December 15, 2023

Re: **Nantucket Shores (PWS ID #95088)**  
**Wells #4, 5, & 6 and Secondary Treatment**  
**Conditional Approval (PR #153-2023)**

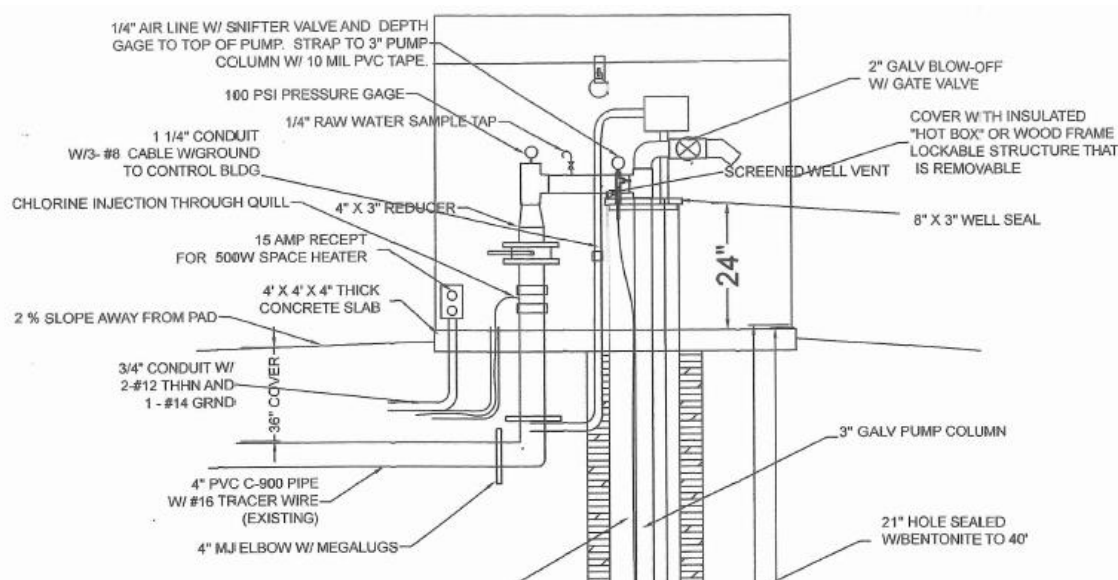
2. Plans and/or photos are submitted that show the above-ground wellhead structure detail including the raw water sample tap, pump to waste piping, flowmeter (totalizer and/or rate of flow), and a way to measure the water level in each well. Plans/photos of the well house covering each well (if the wells are not equipped with a pitless adapter) showing the concrete slab and drainage.

3. Plans, specifications, and/or photos showing how the wells are connected to the water treatment system (I only have the basic footprint of the treatment building shown at right). Plans should include, the make and model of any pumps, pressure tanks, the purpose of any treatment (e.g., iron removal, etc.) and the make/model of treatment equipment as well as product specifications for any chemicals (e.g.,

chlorine) added to treat the water. Since the existing system is chlorinated at the original treatment plant (WTP-A), chlorine will need to be added for the wells as you cannot introduce unchlorinated water into a chlorinated distribution system. Plans/photos should also show raw water (pre-treatment) and post-treatment sample taps. The graphic below is an example of wellhead plans you may use as a reference.

## Geologist Well Log Evaluation Results (12/14/2023)

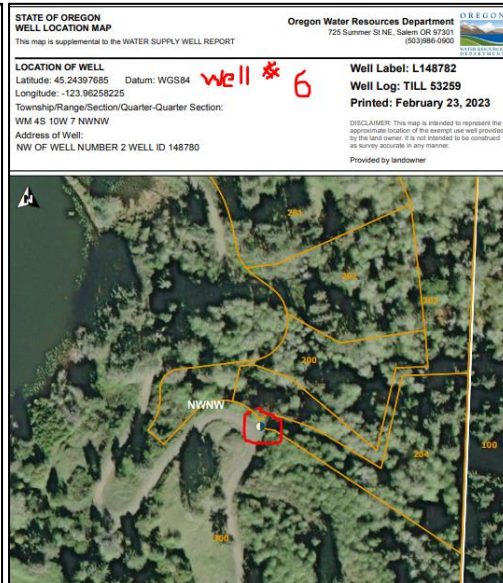
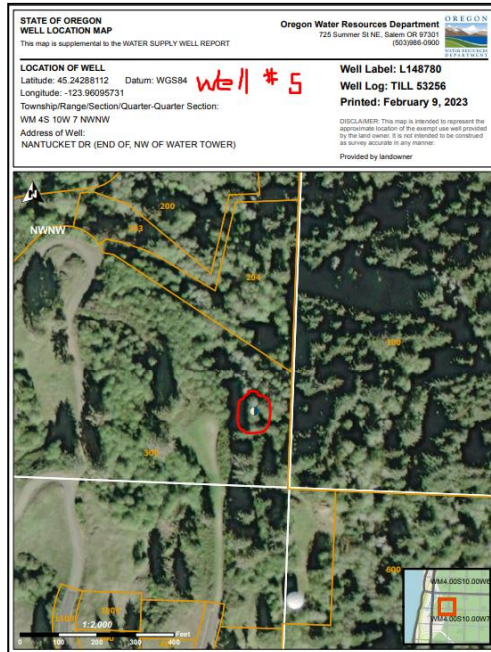
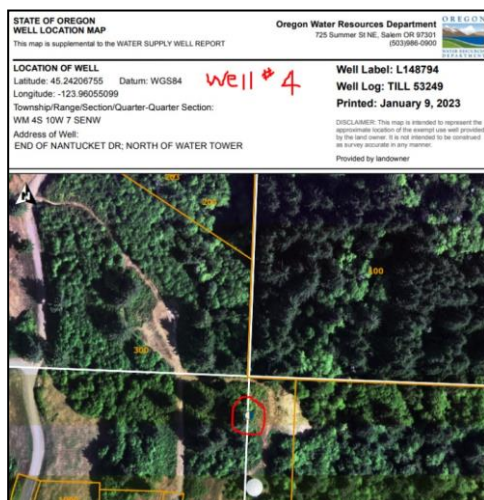
The well logs TILL53249 (Well #4), TILL53256 (Well #5), & TILL53259 (Well #6) were submitted to our geologist, Tom Pattee, on November 30, 2023, who provided the results of his evaluation to me on December 14, 2023. As shown on **page 8** of this letter, **Mr. Pattee found that all 3 wells were adequately constructed and sealed** such that impacts from nearby land use practices should be minimal. Although all the wells draw water from a confined aquifer, **the fractured bedrock of the aquifer for Well #4 does make this well more sensitive to nearby land use practices.** Wells #5 and #6 aquifers are less sensitive since they are constructed to draw water from a deep confined sedimentary aquifer.

Well ID	Well Evaluation Results
Well 4 - <a href="#">TILL 53249</a> - <a href="#">L148794</a> - ca 12-16-22 (closest to reservoir) <a href="#">Exempt Use Map</a>	<input checked="" type="checkbox"/> Well/Spring meets current construction standards. Comments: <u>This well was drilled to a depth of 266 ft and is cased to a depth of 48 ft. The casing seal was constructed to a depth of 47 ft. A screened liner was installed in the well and helps to keep the borehole open. Water can enter the well through the uncased portion of the borehole, below a depth of 48 ft below ground level. Sensitivity Analysis results suggest that well construction does not contribute to the sensitivity of the water supply to nearby land use practices.</u> <b>Nature of Aquifer Evaluation:</b> Aquifer Nature: <input checked="" type="checkbox"/> Confined aquifer <input type="checkbox"/> Semi-confined aquifer <input type="checkbox"/> Unconfined aquifer Comments: <u>This well was constructed to draw water from a fractured sedimentary bedrock aquifer. The identified fractured bedrock water-bearing zone was encountered at a depth of 54 ft. The water-bearing aquifer materials are directly overlain by 52 ft of unfractured siltstone that appears to act as a confining layer. The static-water level rose 34 ft above the depth at which water was first discovered to a final depth of 20 ft below ground level indicating that water in the aquifer is under pressure. Sensitivity Analysis results suggest that aquifer characteristics at this well location are highly sensitive to local land use practices due to the shallow fractured aquifer condition.</u>

Well 5 - <a href="#">TILL 53256</a> - <a href="#">L148780</a> - ca 01-23-23 <a href="#">Exempt Use Map</a>	<input checked="" type="checkbox"/> Well/Spring meets current construction standards. Comments: <u>This well was drilled to a depth of 299 ft and is cased to a depth of 79 ft. The casing seal was constructed to a depth of 77 ft. A screened liner was installed in the well and helps to keep the borehole open. Water can enter the well through the uncased portion of the borehole, below a depth of 79 ft below ground level. Sensitivity Analysis results suggest that well construction does not contribute to the overall sensitivity of the water supply to nearby land use practices.</u> <b>Nature of Aquifer Evaluation:</b> Aquifer Nature: <input checked="" type="checkbox"/> Confined aquifer <input type="checkbox"/> Semi-confined aquifer <input type="checkbox"/> Unconfined aquifer Comments: <u>This well is constructed to draw water from a deep confined sedimentary bedrock aquifer composed of siltstone with sandstone seams. The identified water-bearing zone was encountered at a depth of 157 ft. The water-bearing bedrock is directly overlain by 127 ft of unfractured siltstone that appears to act as a confining layer. The static water-level in the well rose 51 ft above the depth at which water was discovered to a final depth of 106 ft below ground level indicating that water in the aquifer is under pressure. Sensitivity Analysis results suggest aquifer characteristics at this well location are not highly sensitive to local land use practices.</u>

Well ID	Well Evaluation Results, Continued
Well 6 - <a href="#">TILL 53259</a> - <a href="#">L148782</a> - ca 02-01-23 (furthest from res.) <a href="#">Exempt Use Map</a>	<input checked="" type="checkbox"/> Well/Spring meets current construction standards. Comments: <u>This well was drilled to a depth of 249 ft and is cased to a depth of 73 ft. The casing seal was constructed to a depth of 53 ft. A screened liner was installed in the well and helps to keep the borehole open. Water can enter the well through the uncased portion of the borehole, below a depth of 73 ft below ground level. Sensitivity Analysis results suggest that well construction does not contribute to the overall sensitivity of the water supply to nearby land use practices.</u> <b>Nature of Aquifer Evaluation:</b> Aquifer Nature: <input checked="" type="checkbox"/> Confined aquifer <input type="checkbox"/> Semi-confined aquifer <input type="checkbox"/> Unconfined aquifer Comments: <u>This well is constructed to draw water from a deep confined sedimentary bedrock aquifer composed of siltstone with sandstone layers. The identified water-bearing zone was encountered at a depth of 140 ft. The water-bearing bedrock is directly overlain by 140 ft of unfractured siltstone that appears to act as a confining layer. The static water-level in the well rose 137 ft above the depth at which water was first discovered to a final depth of 3 ft below ground level indicating that water in the aquifer is under pressure. Sensitivity Analysis results suggest aquifer characteristics at this well location are not highly sensitive to local land use practices.</u>

## Water Right Transfer Application Map (T13978) vs Map of Constructed Wells

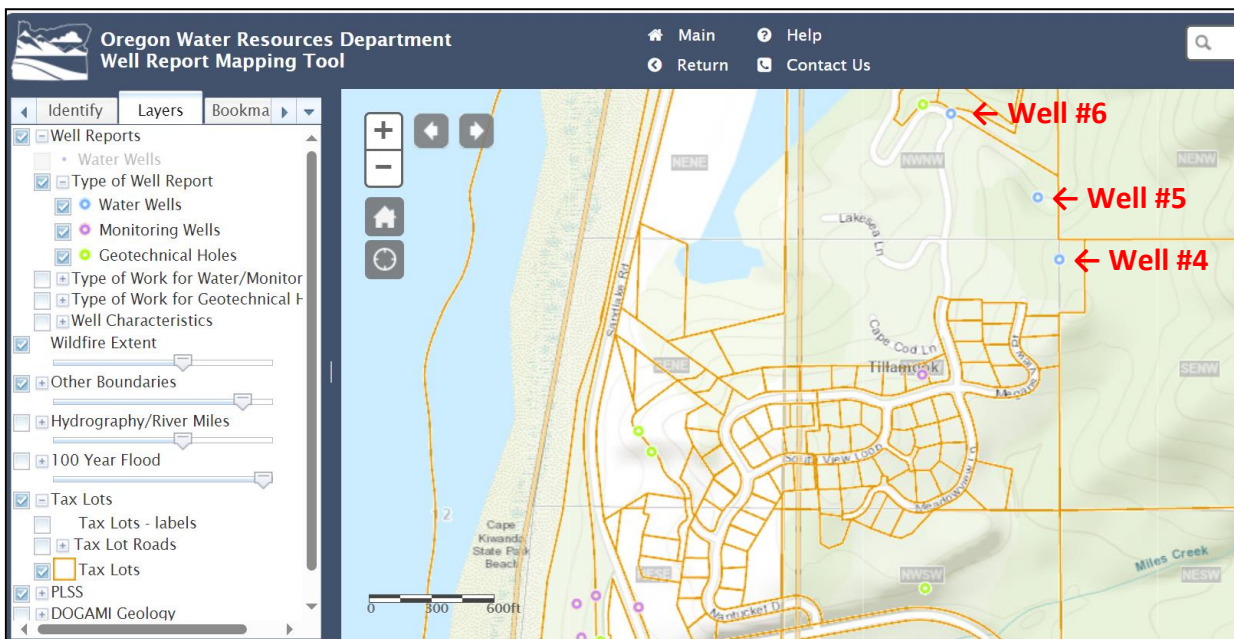
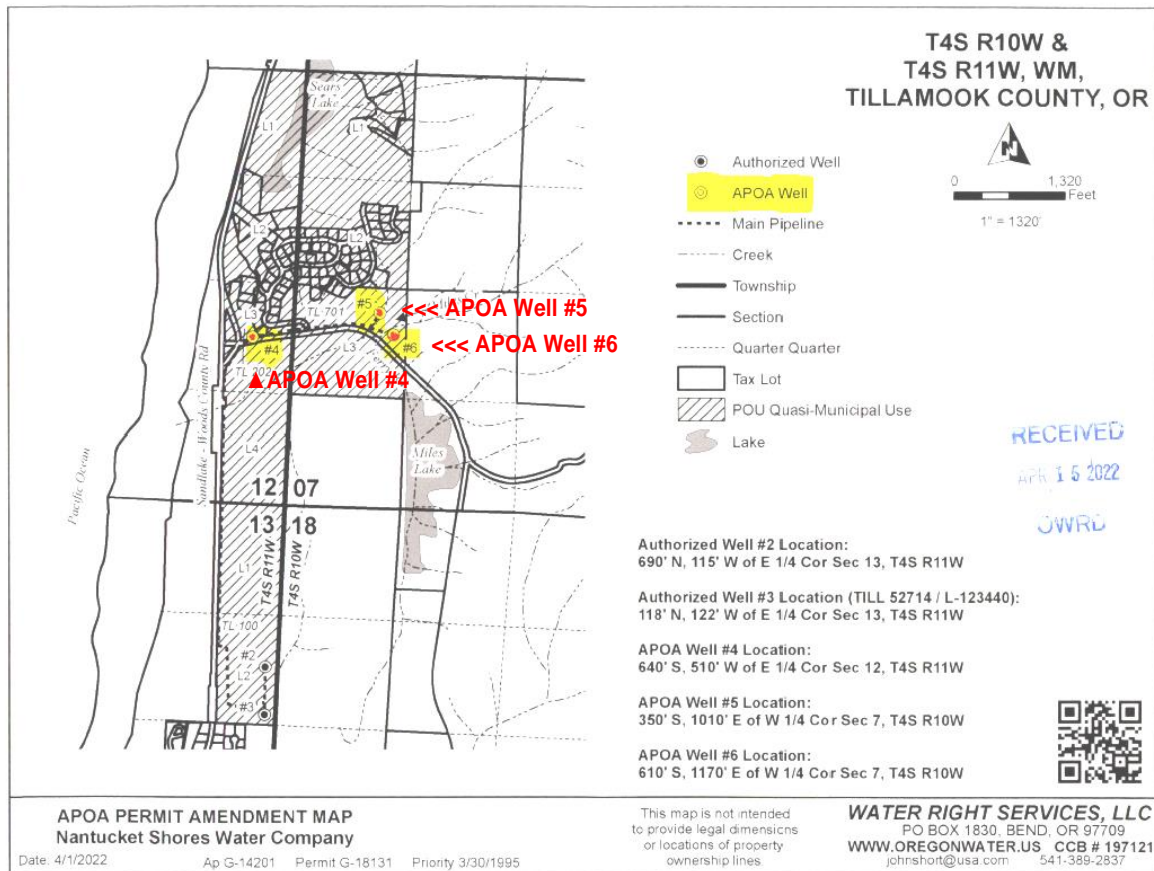
**Please refer to the maps on page 8 of this letter and reach out to the Nikki Hendricks with the Oregon Water Resources Department to clarify the status and applicability of the water right transfer application T13978 to the constructed wells.**
